MEMORANDUM

SUBJECT: BZA Case No. 18002, 900 New York Avenue, NW (Square 474, Lot 45)

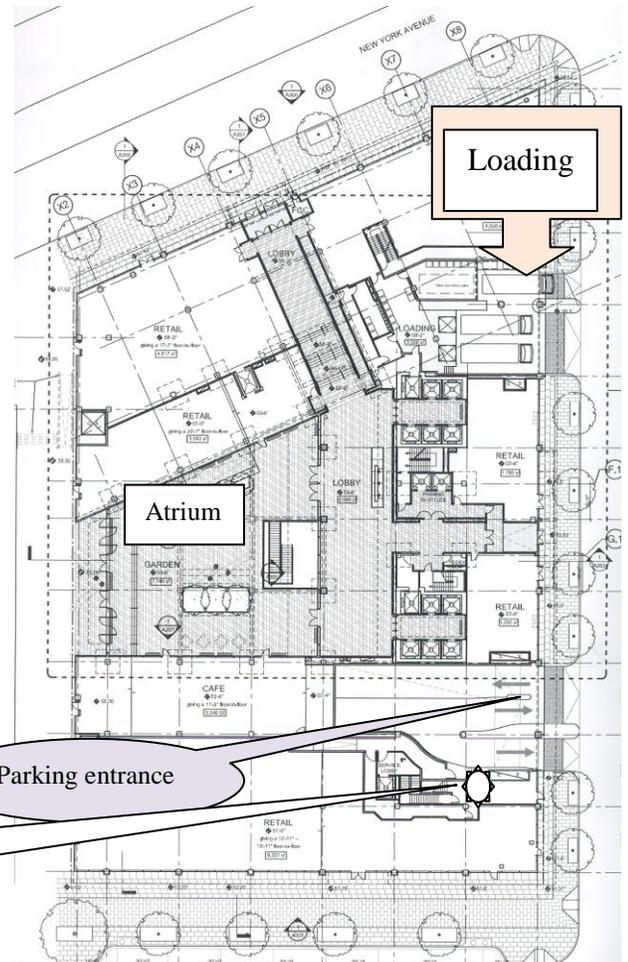
There would be no substantial harm to the public good. As the axonometric view on page 2 shows, the 40 foot wide, 30 foot deep and 22' 6"-high elevator overruns would be only a small portion of the otherwise 18'6" high mechanical penthouses. They would occupy only 4% of the overall roof. The elevator enclosures would be set back from the building face at a 1:1 ratio, making them almost invisible from a close viewpoint. With the required setbacks and clean design of the elevator overruns they would not be noticed or unattractive from medium and long distance viewpoints along 9th Street, New York Avenue, or Mt. Vernon Square.
